720 Williamson
Certificate of Appropriateness
October 16, 2023

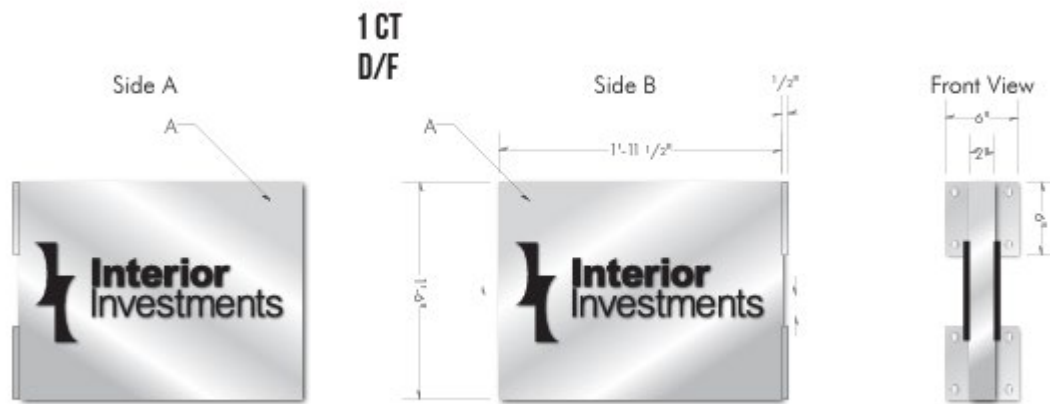
- Installation of a blade sign in pilaster next to entrance

Install Location 10' 1" from Grade

Staff believes that the standards for granting a Certificate of Appropriateness are met and recommends the Landmarks Commission approve the project with the following conditions.

1. Signs be attached to the building at masonry joints using stainless steel fasteners
- ~~2. Approving option 2 for the wall sign with the letters attached to a bar that would then be attached to the building.~~
